Access Compliance Report

Public Rights-of-Way

Intersection ID: 9949	Main Street: AVALON_AV	Cross Street: GLENWOOD_DR	Location: SW
ADA ID: 42E69976CA15	Ramp Type: Perp	Initial Pass/Fail: Fail	Overall Compliance: No
		Severity Score: 25

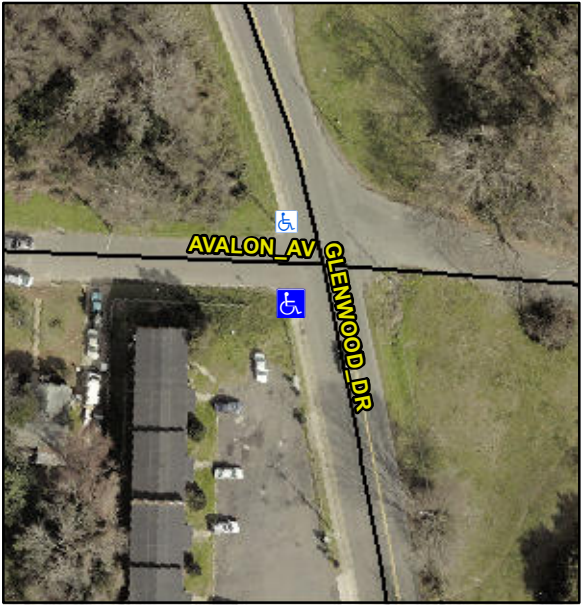
Codes/Mitigation Info/Possible Solution			Field Measurements/Component Compliance		
	Possible Solutions:		Compliance	Description	Data
	Remove & Replace Entire Ramp.		Yes	Ramp Length (in)	50.0
			N/A	Ramp Width (in)	48.0
			N/A	Flare Type LT	N/A
			N/A	Flare Slope LT (%)	N/A
			N/A	Flare Traversable LT?	N/A
			N/A	Landing Length (in)	N/A
			N/A	Landing Width (in)	N/A
			N/A	Landing Slope (%)	N/A
			N/A	Landing X Slope (%)	N/A
Surveyor Notes: N/A			N/A	Landing Curb? (Y/N)	N/A
			N/A	Shared Landing?	N/A
			N/A	Gutter Ponding?	N/A
			N/A	Gutter Lip Ht (in)	N/A
			N/A	Painted X Walk1?	No
			N/A	X Walk 1 Direction	To N
			N/A	X Walk 1 Width (in)	N/A
			N/A	X Walk 1 Slope (%)	7.1
			N/A	X Walk 1 X Slope (%)	10.1
			N/A	Ramp inside XWalk1?	N/A
PROW/ADA: Not Found, R304.5.3			N/A	Ramp inside XWalk2?	N/A
			N/A	Road Slope (%)	N/A
			N/A	Road X Slope (%)	N/A
			N/A	Any Obstructions?	N/A
			N/A	Obstruction Type	
			N/A		
			N/A
